CAMPBELL COUNTY UTILITIES AND SERVICE AUTHORITY

Bidding Addendum

Addendum No. 1 for Campbell County Utilities and Service Authority Timberlake Road Office Renovation: Project Number 80-2214, W|W Comm. No. 222123, dated October 26, 2022.

Civil Diagram

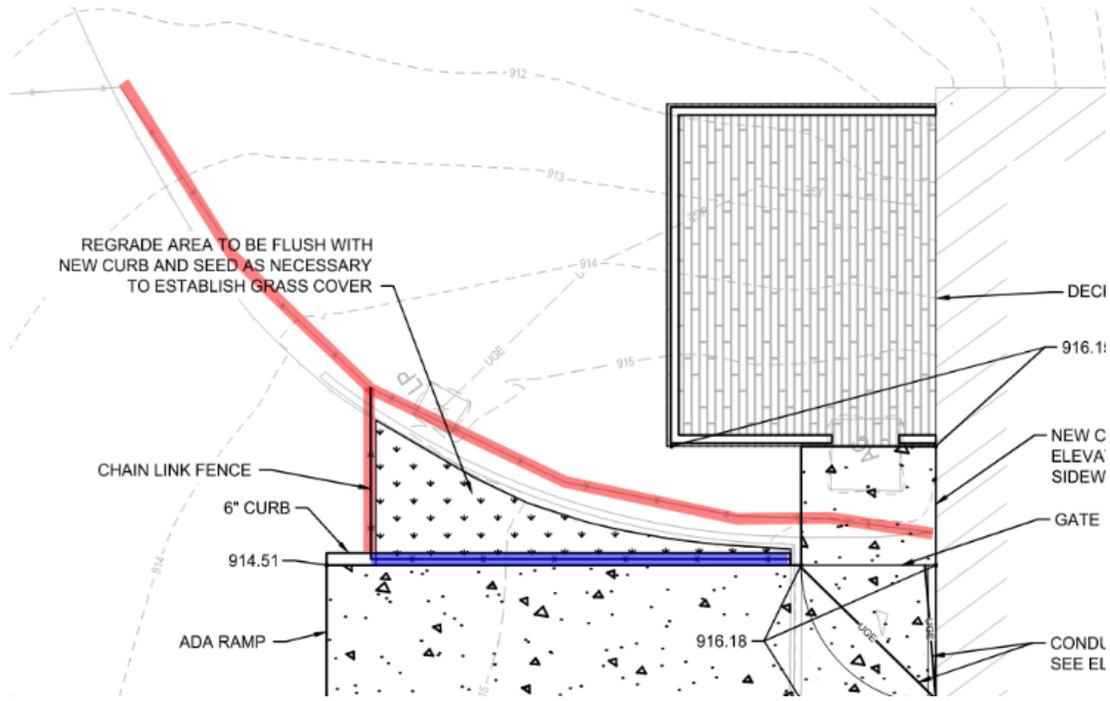
13. **Q:** Should the HVAC Pad demolition be included in base bid or alternate?
A: This should be included in the base bid.
14. **Q:** The existing fence footers are covered up by soil and grass, but on C-101, it shows exposed top of footing. Please advise.
A: Existing footers will remain covered by soil & grass with no above-grade foundation (red). But the posts along the new ramp will be in the curb along the edge of that ramp (blue).
(See attached civil diagram.)
